**Addendum No. 3**

**Final Environmental Impact Report  
for Metro Gold Line Foothill Extension - Azusa  
to Montclair (SCH 2010121069)**

**Evaluating Minor Design Changes of the Project  
Azusa to Montclair**

Metro Gold Line Foothill Extension Construction Authority  
March 2016

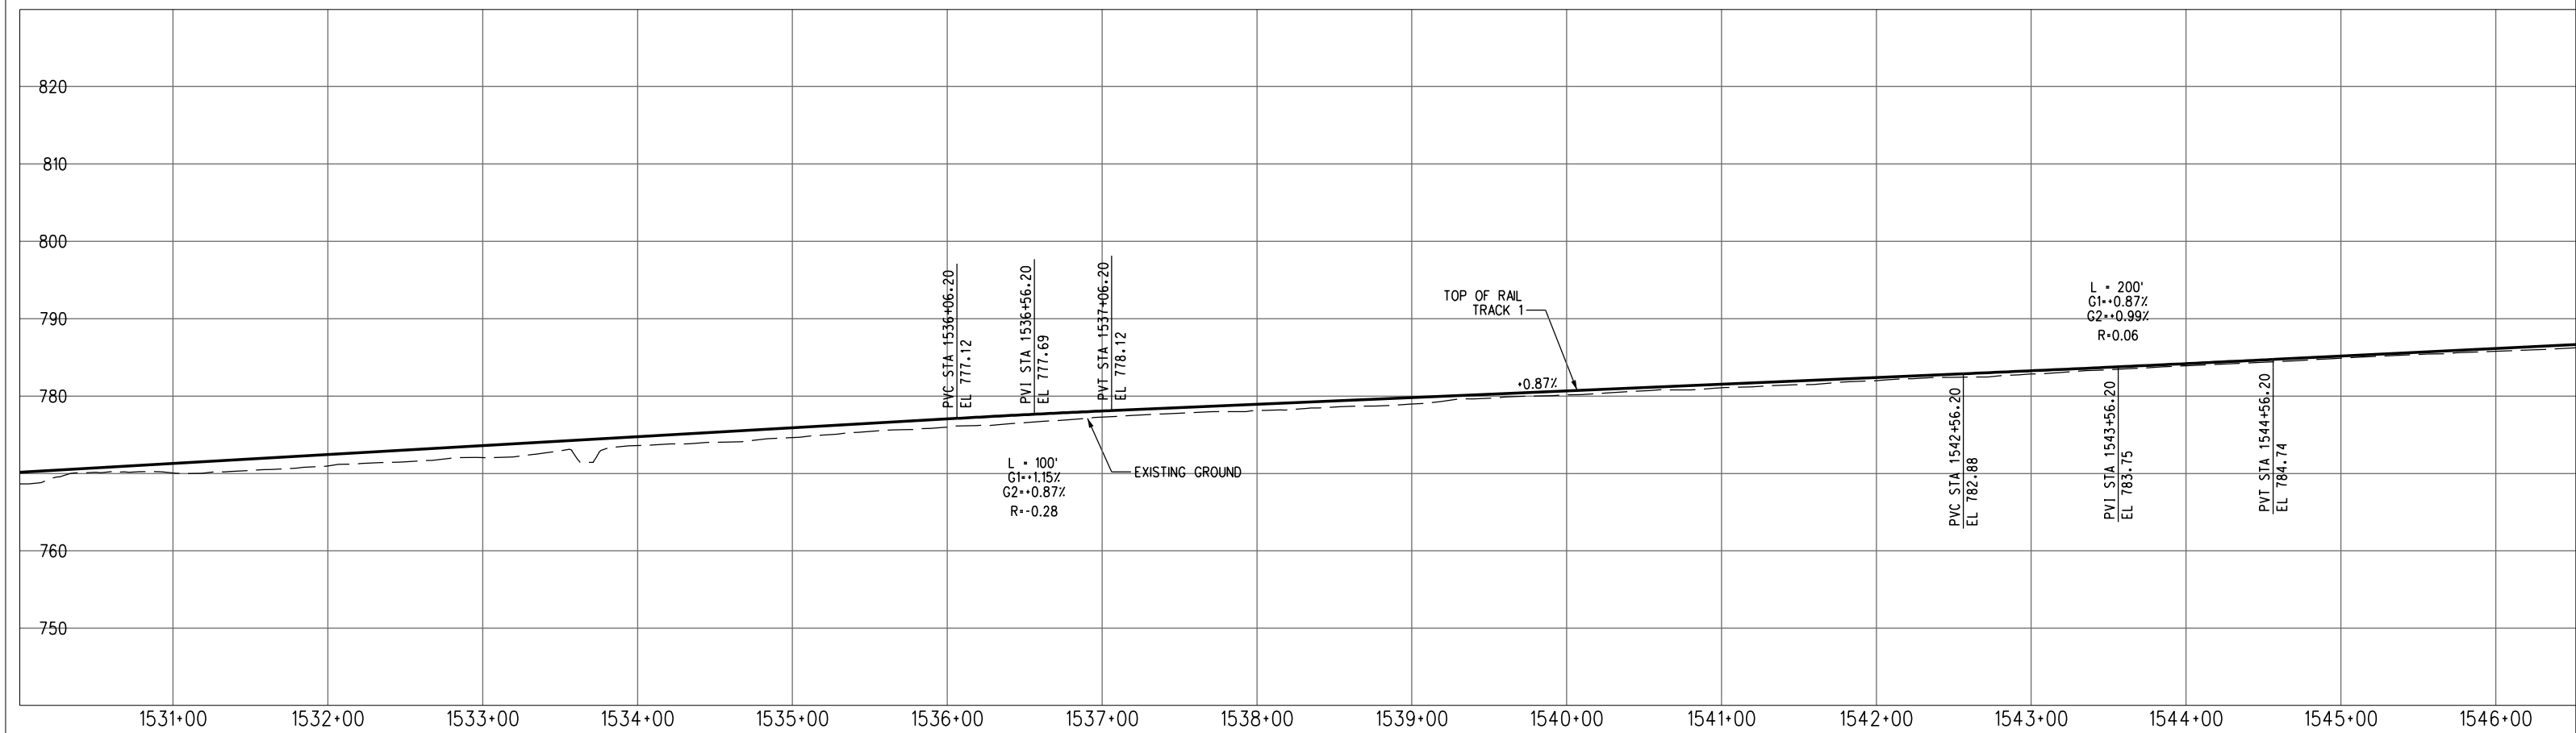
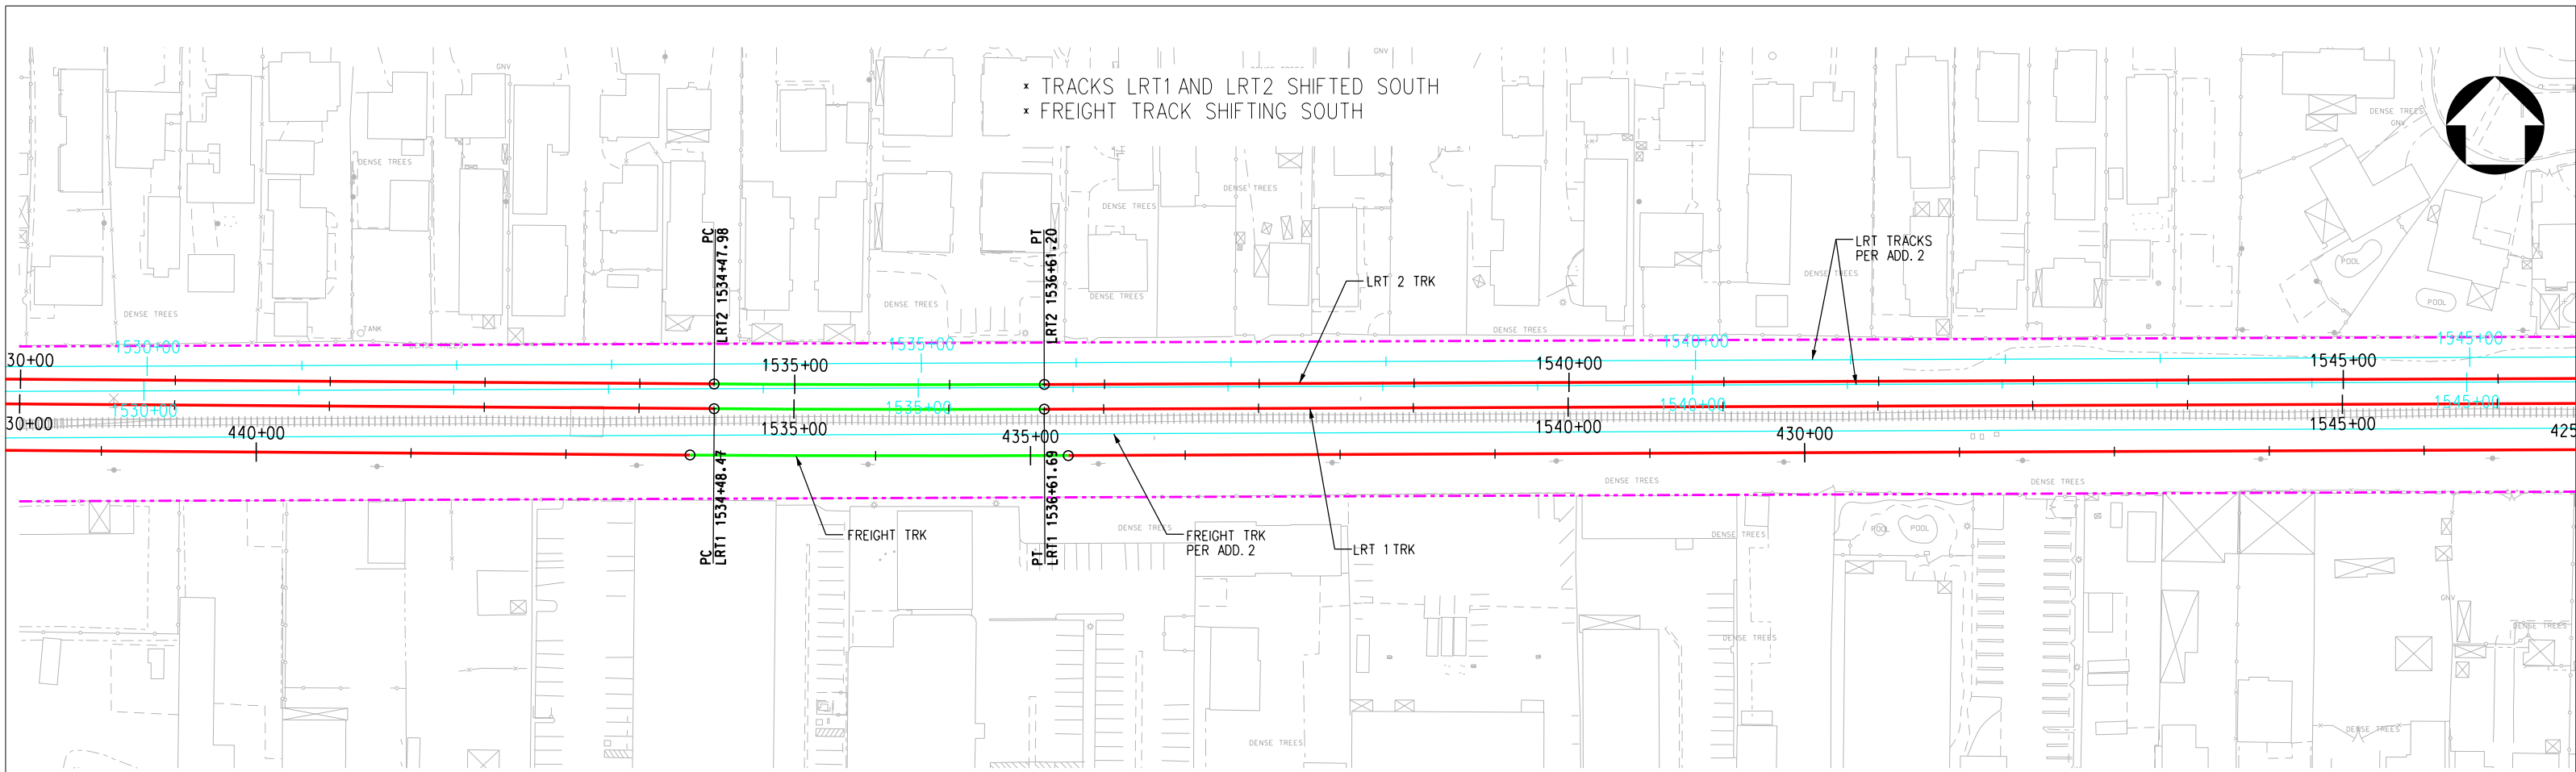
- \* GRADE SEPARATE FOOTHILL BLVD AND GRAND AVE
- \* TRACKS LRT1 AND LRT2 SHIFTED
- \* FREIGHT TRACK SHIFTING NORTH
- \* ADDED 2 NEW #20 CROSSOVERS
- \* END OF BRIDGE
- \* ALT LOCATION FOR TPSS SITE

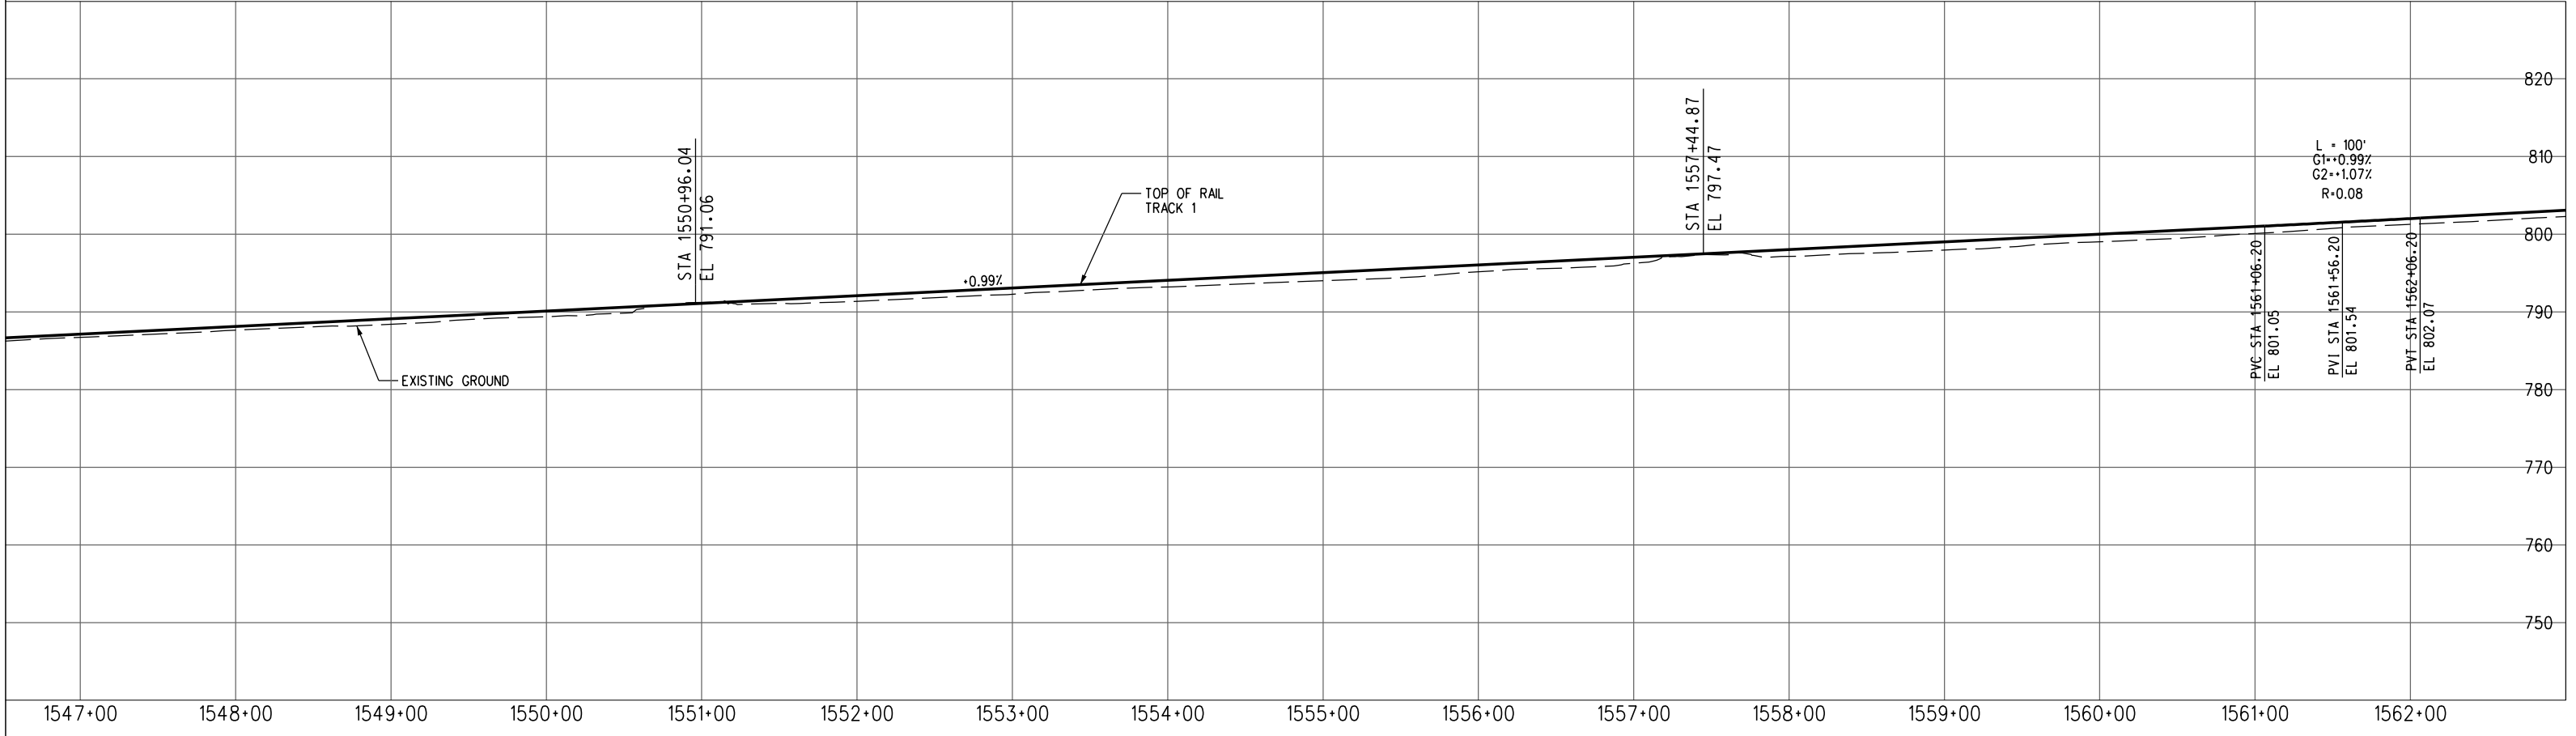
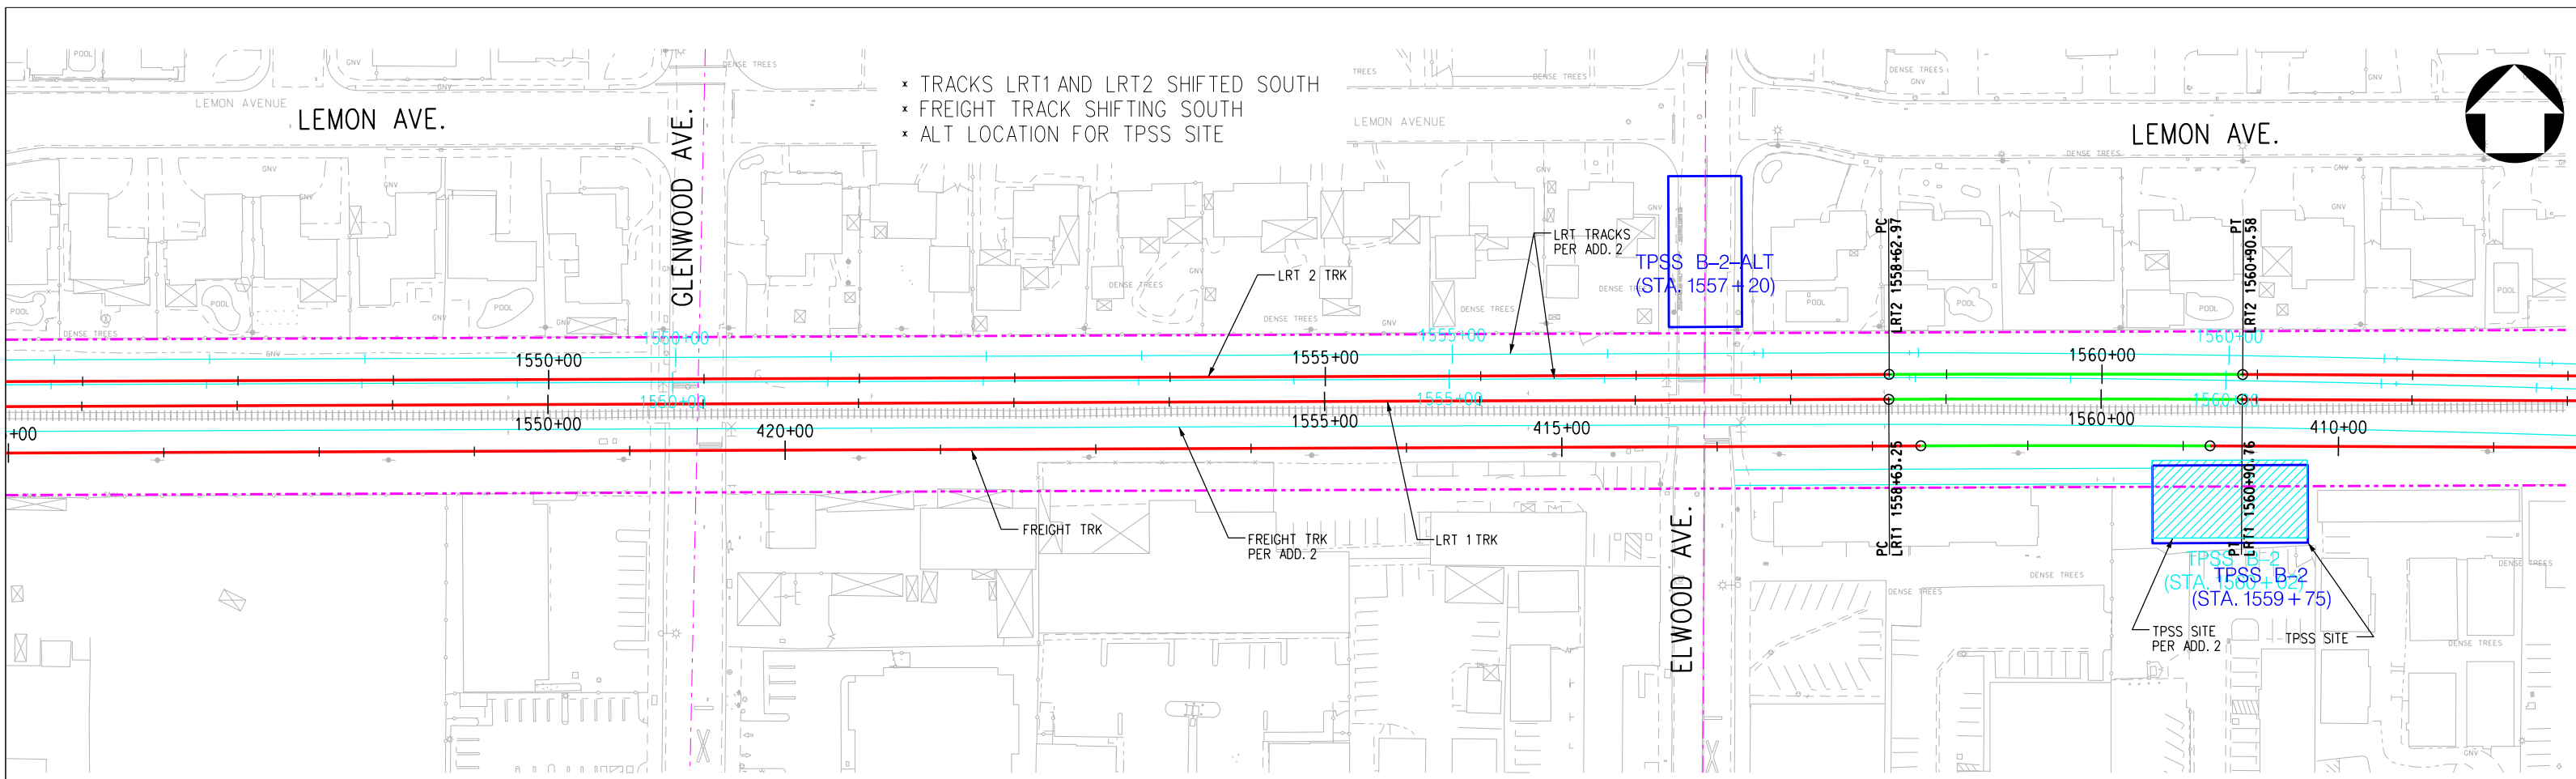
- ✦ TRACKS LRT1 AND LRT2 SHIFTED SOUTH
- ✦ FREIGHT TRACK SHIFTING SOUTH
- ✦ ALT LOCATION FOR TPSS SITE
